ADDENDUM NO. 2
CONTRACT NO. CP8126-1 – GENERAL, MECHANICAL AND
ELECTRICAL CONSTRUCTION
 DATED: SEPTEMBER 27, 2010

SUFFOLK COUNTY DEPARTMENT OF PUBLIC WORKS
DIVISION OF SANITATION
HAUPPAUGE INDUSTRIAL PARK
S.C.S.D. NO. 18 – INDUSTRIAL SEWER DISTRICT EXPANSION
SUFF 0503

SUFF 0503
ADDENDUM #2 - ITEM U
SHEET MPT8 - SKETCH # 12

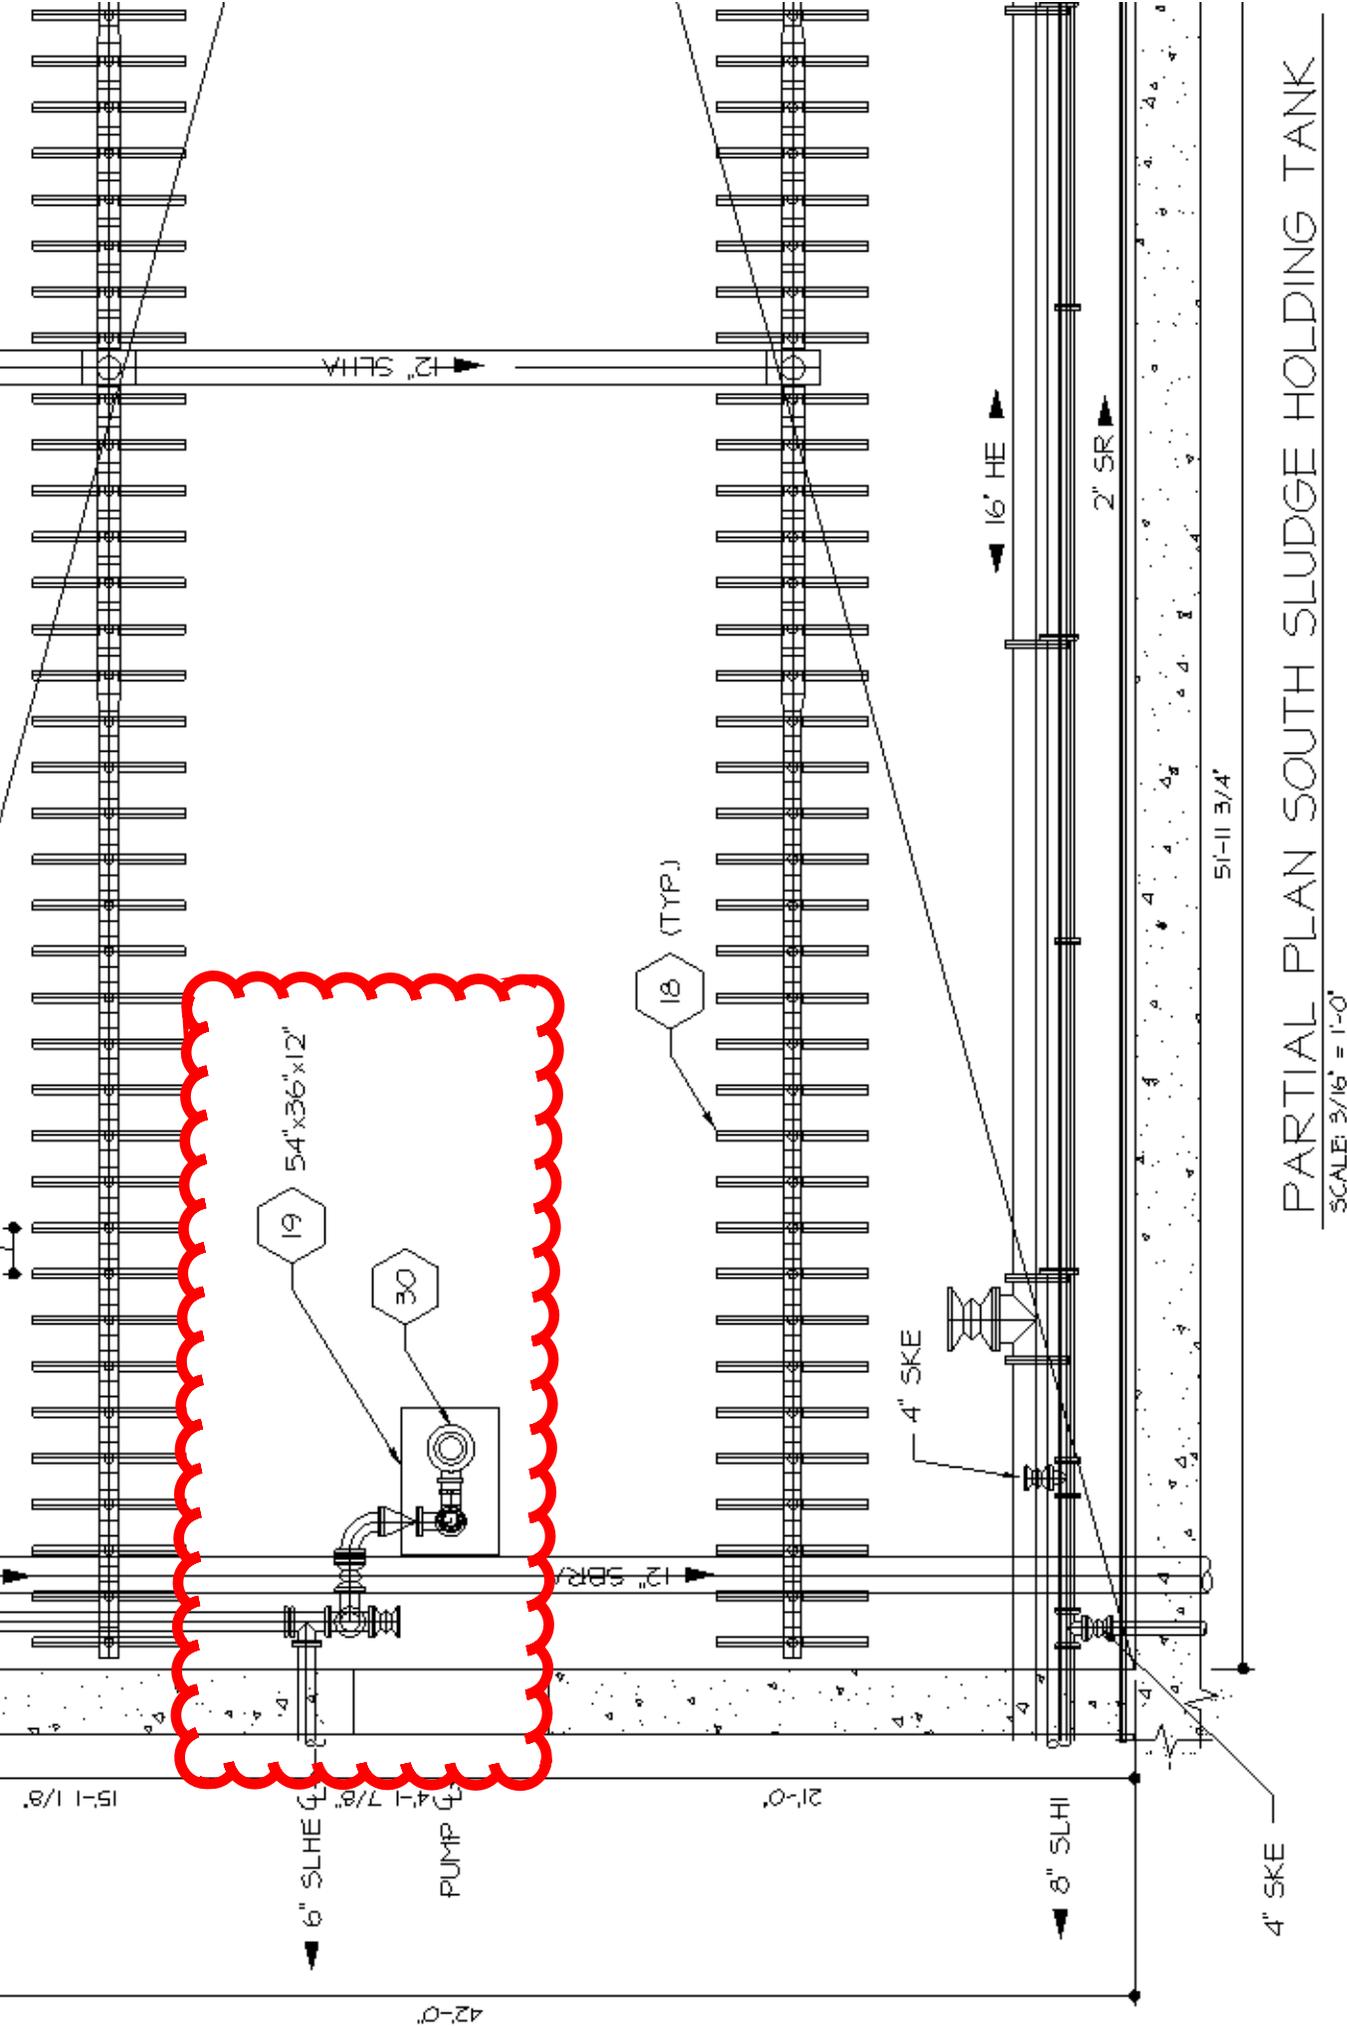
1. Locate specified 6” diameter ball check valves on the above tank top piping for Sludge Holding Tank pumps in the South and North Sludge Holding tanks as shown on the attached Sketches #12 & #13. Relocate the plug valve on the South Sludge Holding Tank pump discharge to piping downstream of check valve.

SUFF 0503
ADDENDUM #2 - ITEM V
SHEET MOB3 - SKETCH # 14

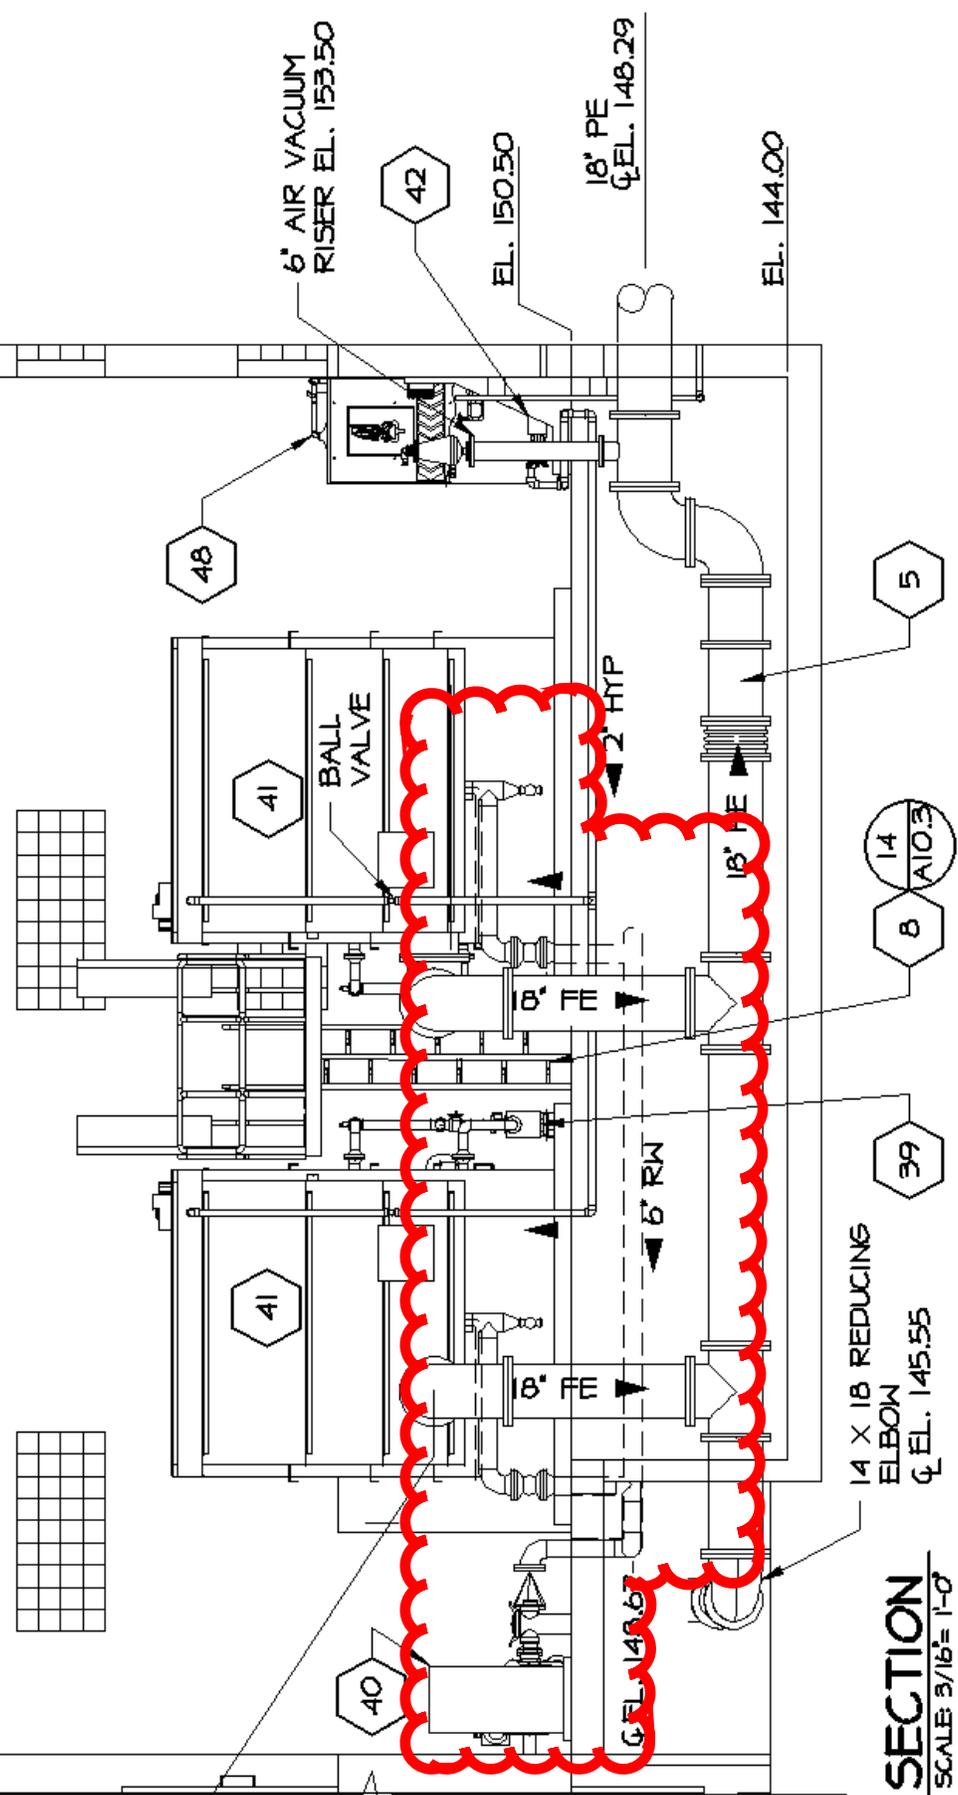
1. Change size of recycled water line upstream of booster pump station within filter room from 2-inch & 4-inch to 6-inch. (see sketch #14 included herein – depicts sheet MOB3 only)

SHEET MD11 - SKETCH # 15

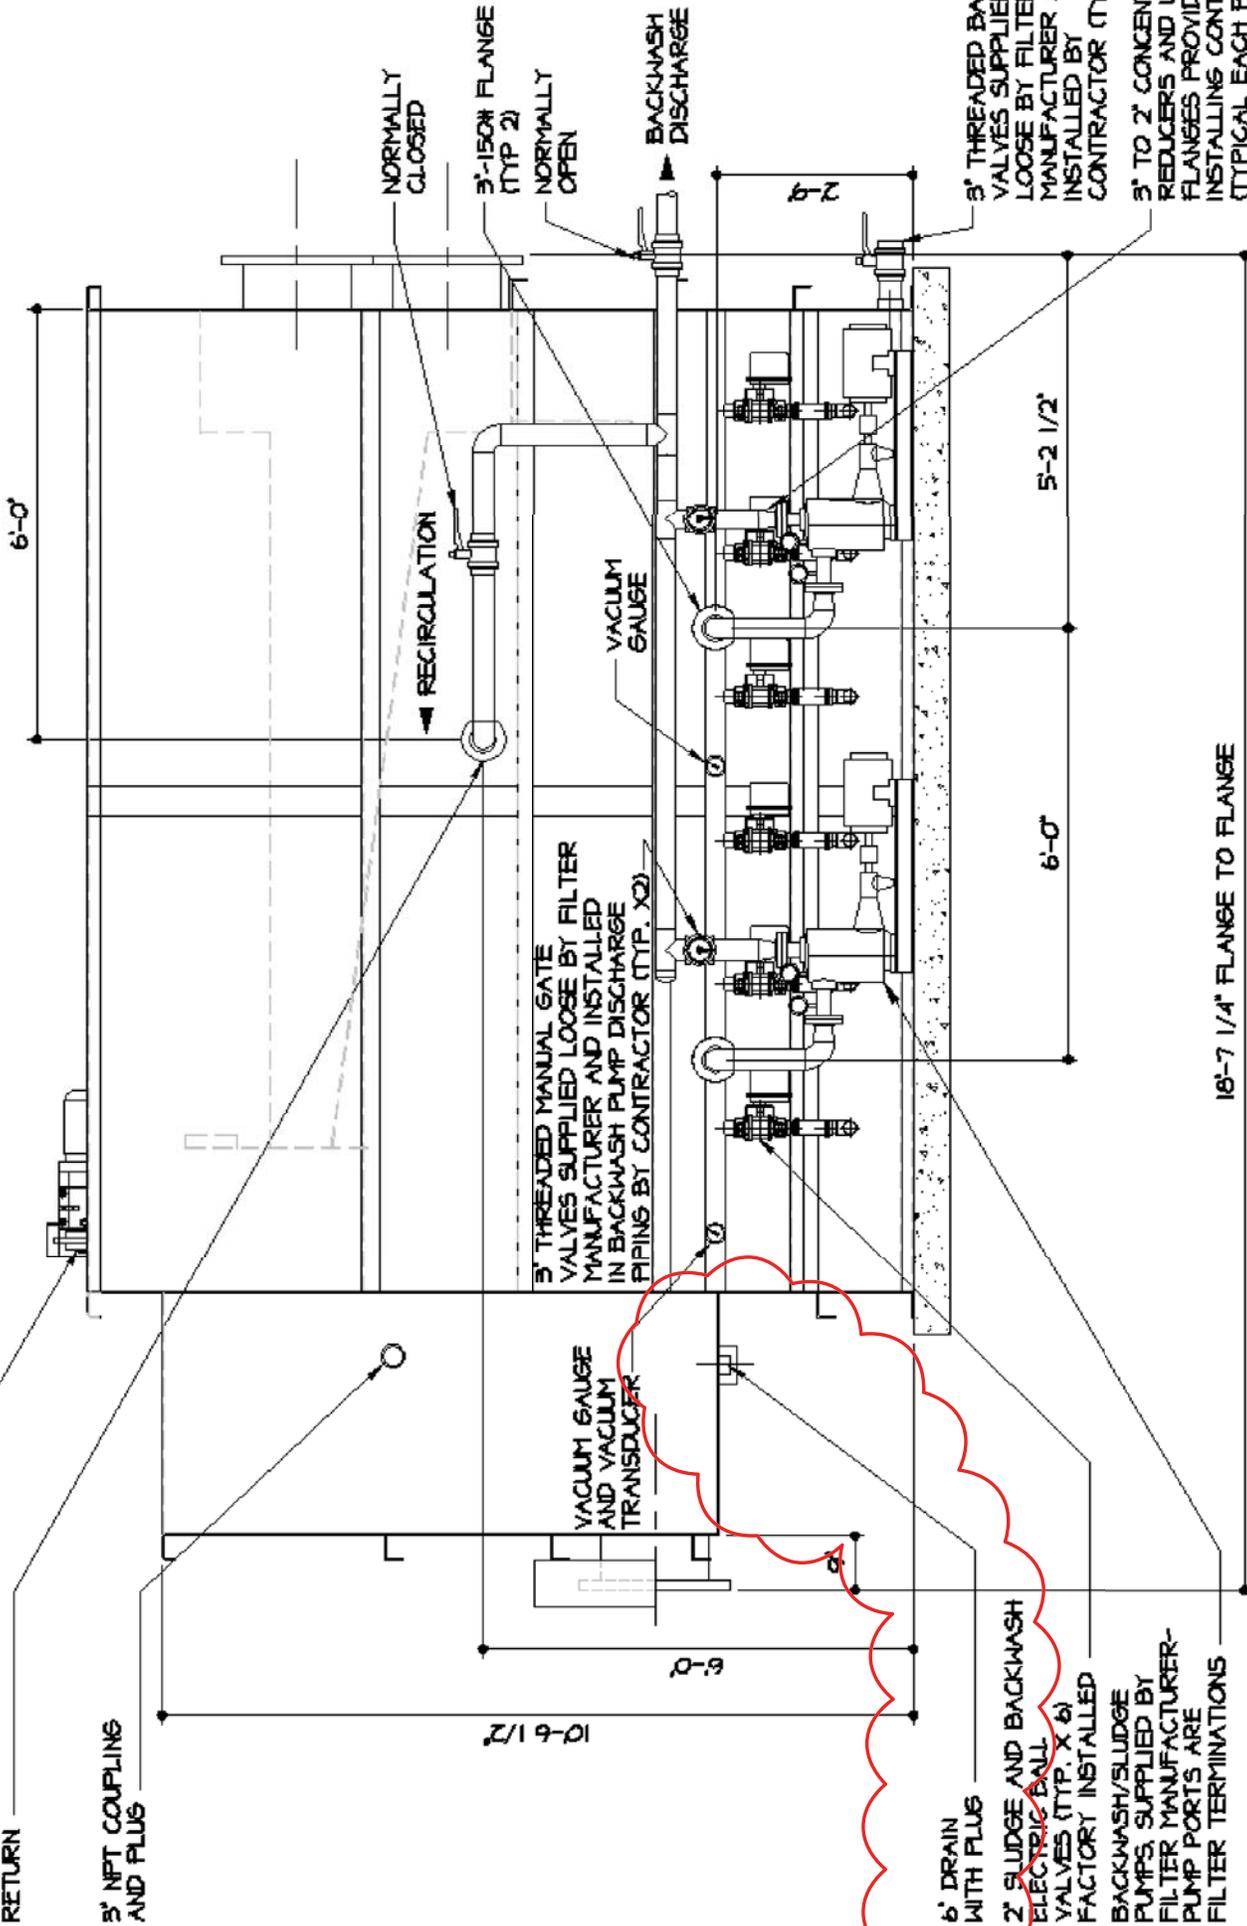
1. Section “A”: Modify size of drain from 2-inch to 6-inch. (see sketch #15 included herein)
